SUNDRY NOTICES AND REPORTS ON WELLS

8. Well Name and No.
PHILLY 31 FED COM 707H

EOG respectfully requests an amendment to our approved APD for this well to reflect changes in the BHL,casing program, and cement See the attached supporting documents.

Proposed Wellbore Design A
Revised 5/9/2019
API: 30-025-44764

WELL LOCATION AND ACREAGE DEDICATION PLAT

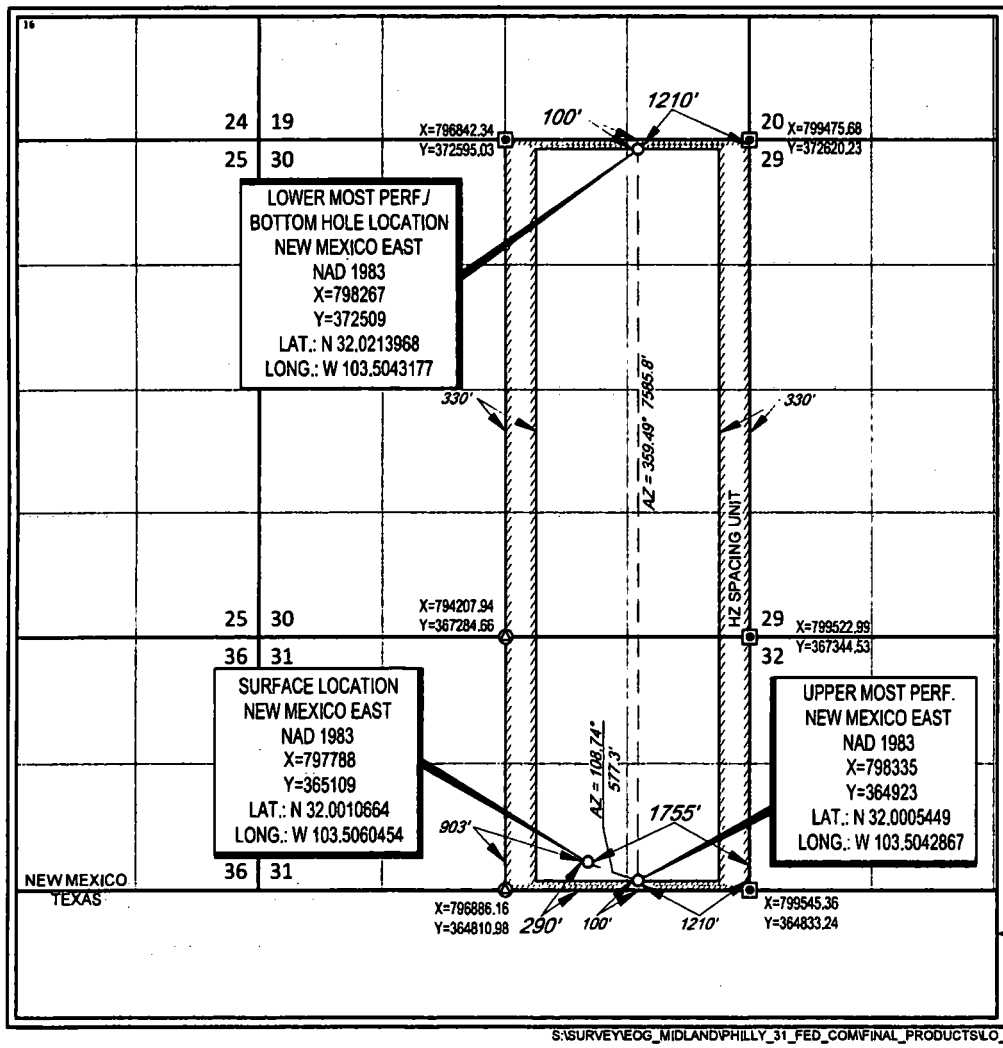
UL or lot no.	Section	Township	Range	Lot Idn	Feet from the	North/South line	Feet from the	East/West line	County
4	31	26-S	34-E	-	290'	SOUTH	1755'	EAST	LEA

UL or lot no.	Section	Township	Range	Lot Idn	Feet from the	North/South line	Feet from the	East/West line	County
A	30	26-S	34-E	-	100'	NORTH	1210'	EAST	LEA

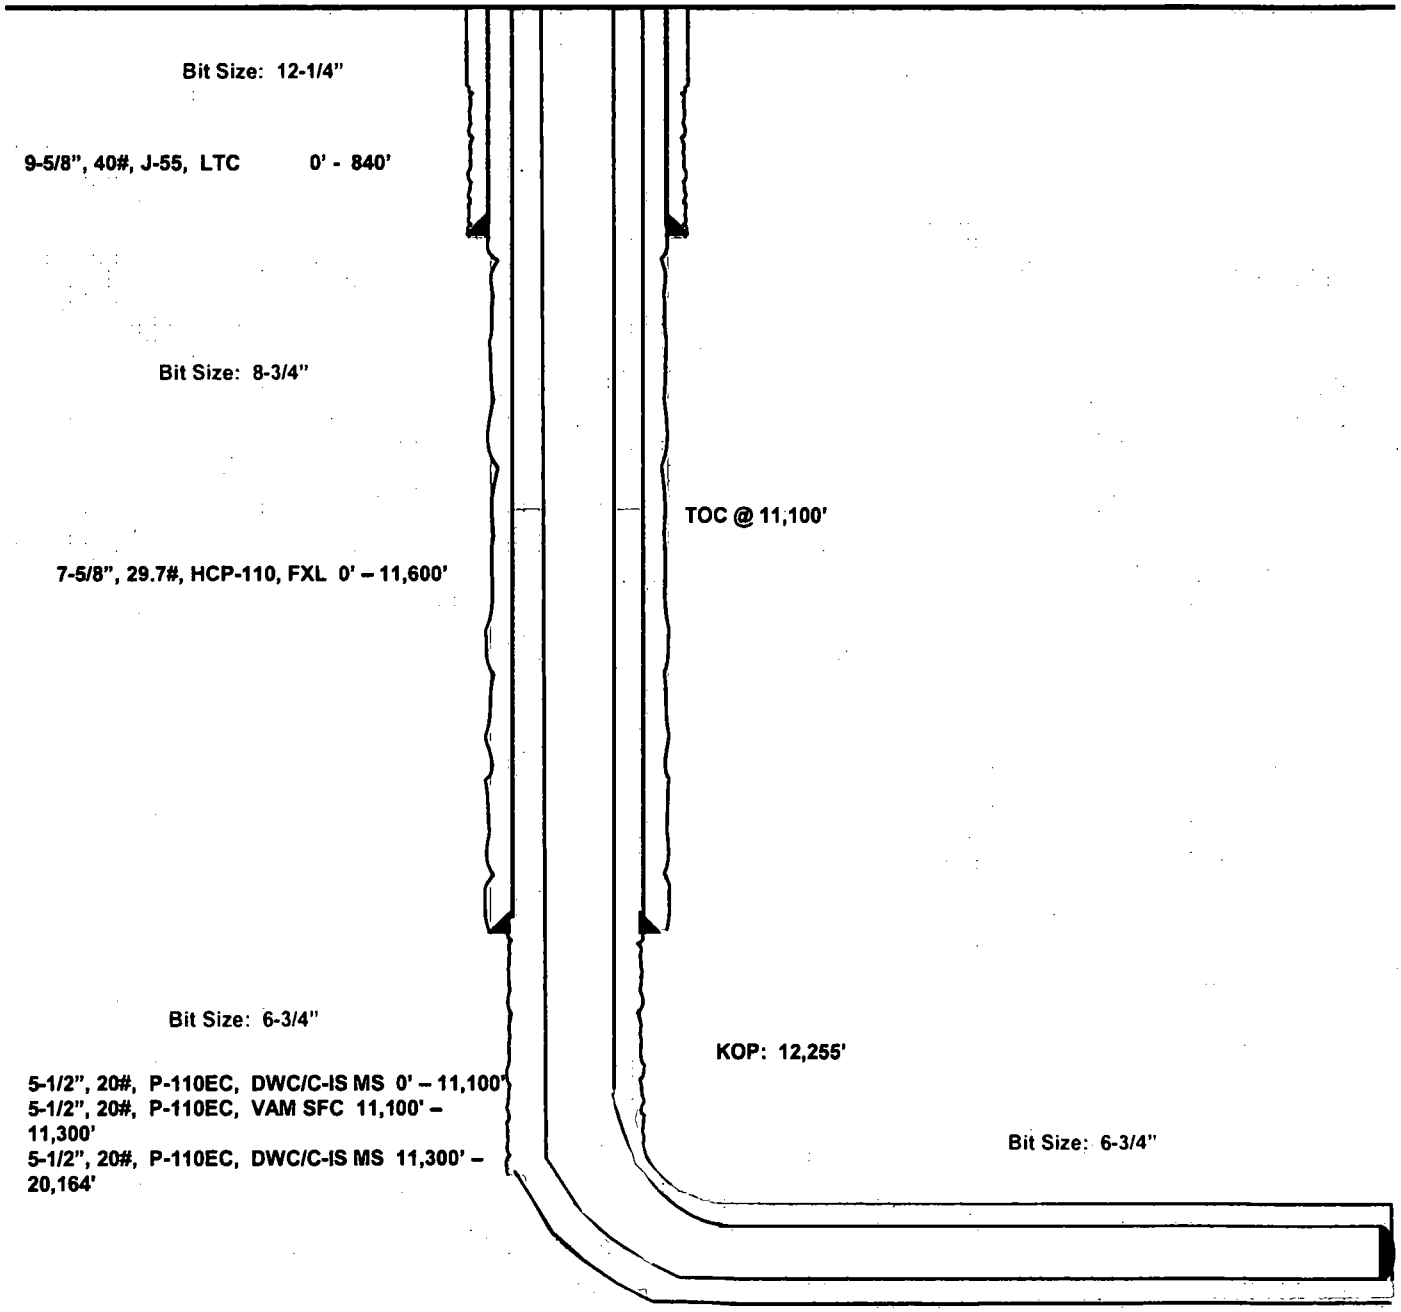
Lateral: 20,164' MD, 12,713' TVD
Upper Most Perf:
100' FSL & 1210' FEL Sec. 31
Lower Most Perf:
100' FNL & 1210' FEL Sec. 30
BH Location: 100' FNL & 1210' FEL
Section 30
T-26-S, R-34-E

Revised Permit Information 5/9/2019:

Location:
SHL: 290' FSL & 1755' FEL, Section 31, T-26-S, R-34-E, Lea Co., N.M.
BHL: 100' FNL & 1210' FEL, Section 30, T-26-S, R-34-E, Lea Co., N.M.

Hole Size	Interval	Csg OD	Weight	Grade	Conn	DF_{min} Collapse	DF_{min} Burst	DF_{min} Tension
12.25"	0 – 840'	9.625"	40#	J-55	LTC	1.125	1.25	1.60
8.75"	0 – 11,600'	7.625"	29.7#	HCP-110	MO-FXL	1.125	1.25	1.60
6.75"	0' – 11,100'	5.5"	20#	P-110EC	DWC/C-IS MS	1.125	1.25	1.60
6.75"	11,100' – 11,600'	5.5"	20#	P-110EC	VAM SFC	1.125	1.25	1.60
6.75"	11,600' – 20,164'	5.5"	20#	P-110EC	DWC/C-IS MS	1.125	1.25	1.60

Variance is requested to wave the centralizer requirements for the 7-5/8" FJ casing in the 8-3/4" hole size. An expansion additive will be utilized, in the cement slurry, for the entire length of the 8-3/4" hole interval to maximize cement bond and zonal isolation.

Variance is also requested to wave any centralizer requirements for the 5-1/2" FJ casing in the 6-3/4" hole size. An expansion additive will be utilized, in the cement slurry, for the entire length of the 6-3/4" hole interval to maximize cement bond and zonal isolation.

EOG requests variance to allow deviation from the 0.422'' annulus clearance requirement from Onshore Order #2 under the following conditions:

- Annular clearance to meet or exceed 0.422'' between intermediate casing ID and production casing coupling only on the first 500' overlap between both casing strings.
- Annular clearance less than 0.422'' is acceptable for the curve and lateral portions of the production open hole section.

A. CASING

1. The **9 5/8"** surface casing shall be set at approximately **870 feet** (a minimum of 25' into the Rustler Anhydrite and above the salt) and cemented to surface.

2. The **7 5/8"** intermediate casing shall be set at **11,700 feet** and the minimum required fill of cement is:

3. The minimum required fill of cement behind the **5-1/2"** production casing is:

- Cement should tie-back at least **200 feet** into previous string. Operator shall provide method of verification.
